# PROPOSED DEVELOPMENT: THREE MULTIPLE DWELLINGS AND ONE COMMERCIAL SPACE

APPLICATION NO: 5.2025-114.1 DATE: 03/10/2025

Development Application: 5.2025.114.1 - Response To Request For Information - 17 Dubs

I am writing in response to the Request for Further Information (RFI) received on 09<sup>th</sup> May 2025, regarding planning application 5.20251114.1 for the proposed mixed-use building at **17 Dubs & Co Drive, Sorell**.

SITE PLAN - PROPOSED

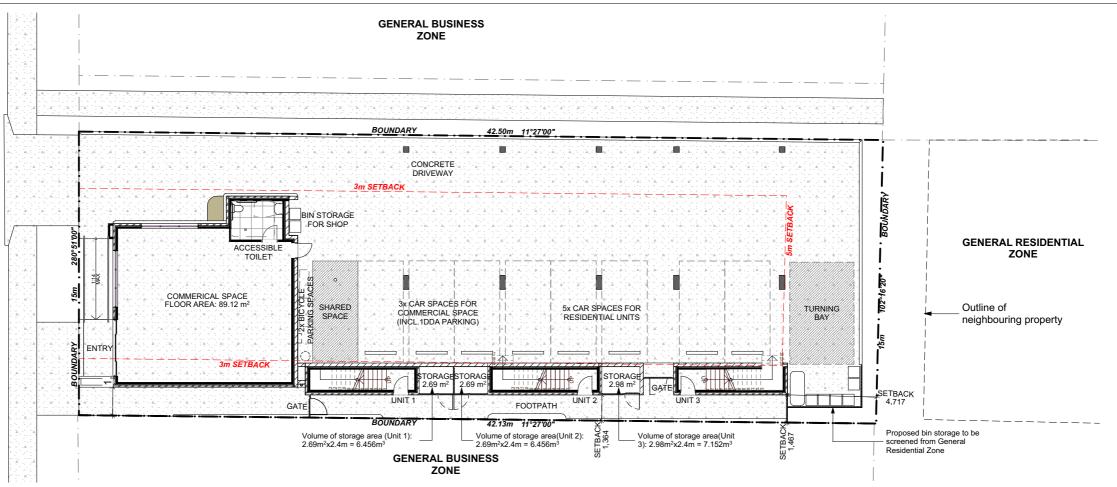
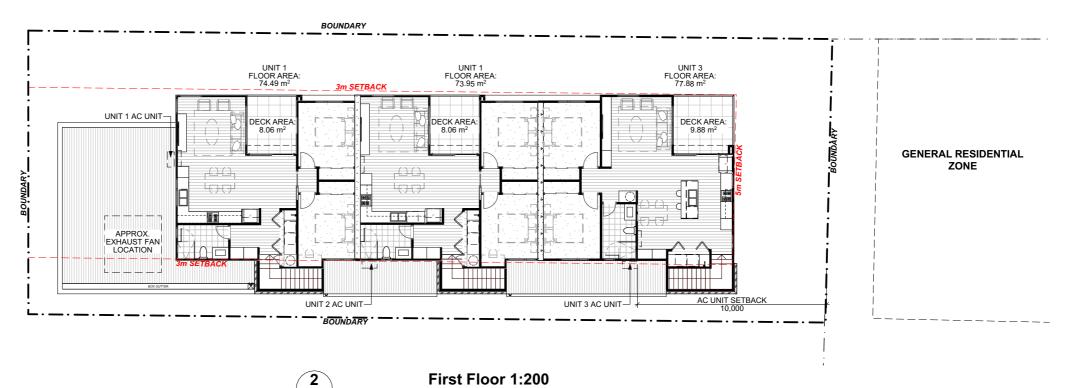
### **COUNCIL RFI:**

Please confirm the volume of storage areas as shown, relative to each dwelling in accordance clause 15.4.6 Dwellings.

## MKDD RESPONSE:

There are secured storage spaces for each unit located near each unit entry, with areas of 2.69
